# Service Bulletin

Bulletin No.: PI1241

**Subject:** Tire Pressure Monitor (TPM) Light On and/or Loss of TPM Reading Displayed on DIC

**Models:** 2013-2014 Chevrolet Camaro  
Equipped with Remote Start (RPO S6P)

3815489

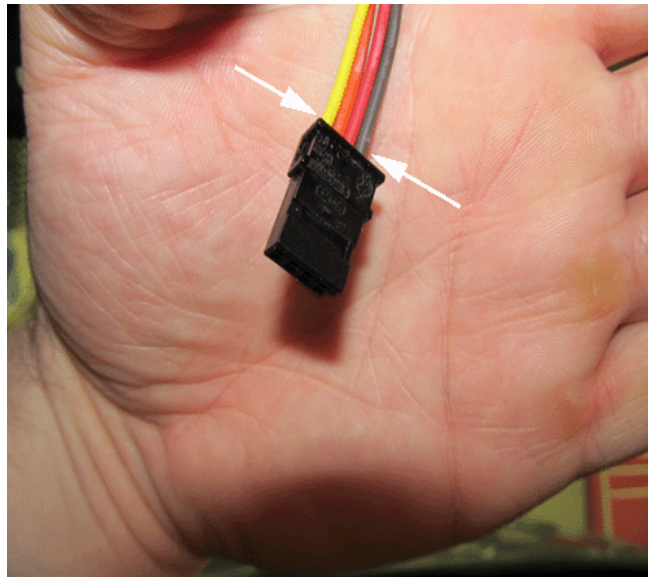
6. Remove the connector from the remote control door lock receiver, shown in the illustration above, cut wires and remove the terminals from the connector.

3816006

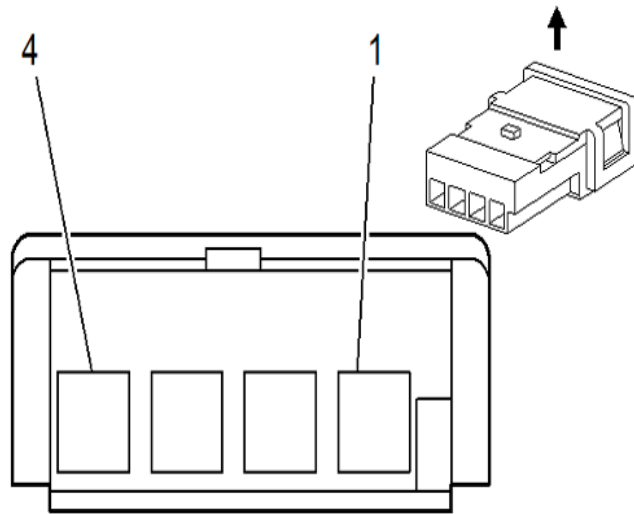
8. Crimp the terminal 92899-5 to one end on each lead. Install terminals into each cavity 1 through 4 of the remote control door lock receiver connector shown above.
9. Re-connect the connector to the remote control door lock receiver and route the wires up in the headliner down the driver side windshield garnish molding to the BCM connectors.

3815886

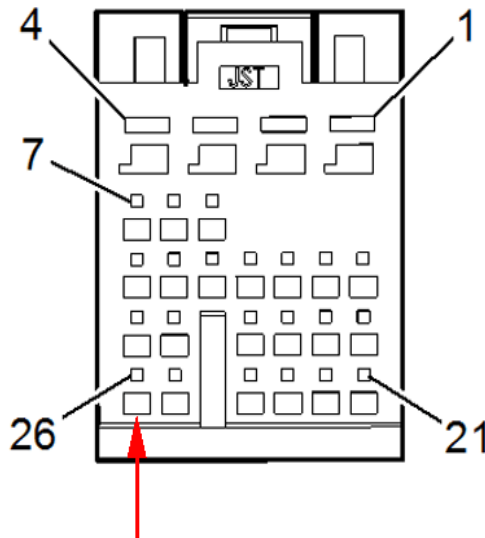
K9 Body Control Module (BCM) X1 shown in the illustration above.

12. Crimp the terminal SNAC-A061T-M2.8 on lead 3 of the remote control door lock receiver. Remove the old terminal before installing the new terminal into cavity 26 of the K9 Body Control Module (BCM) X1 connector, shown in the illustration above.

3815884

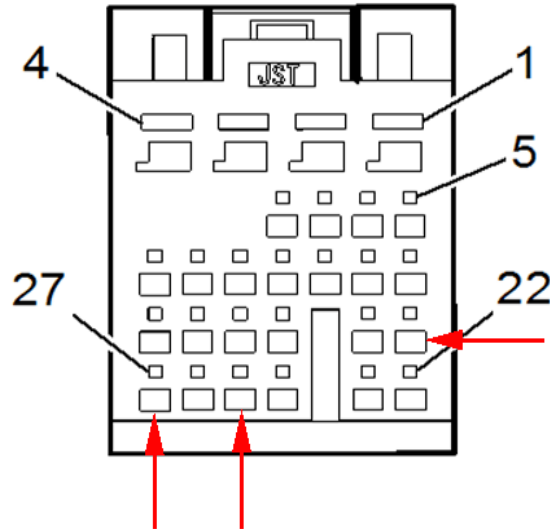
K9 Body Control Module (BCM) X2 shown in the illustration above.

**Note:** When looking at connectors K9 Body Control Module (BCM) X1 and X2, count the cavities from right to left.

10. Crimp the terminal SNAC-A061T-M2.8 on lead 1 of the remote control door lock receiver. Remove the old terminal before installing the new terminal into cavity 16 of the K9 Body Control Module (BCM) X2 connector, shown in the illustration above.

11. Crimp the terminal SNAC-A061T-M2.8 on lead 2 of the remote control door lock receiver. Remove the old terminal before installing the new terminal into cavity 27 of the K9 Body Control Module (BCM) X2 connector, shown in the illustration above.

13. Crimp the terminal SNAC-A061T-M2.8 on lead 4 of the remote control door lock receiver. Remove the old terminal before installing the new terminal into cavity 25 of the K9 Body Control Module (BCM) X2 connector, shown in the illustration above.
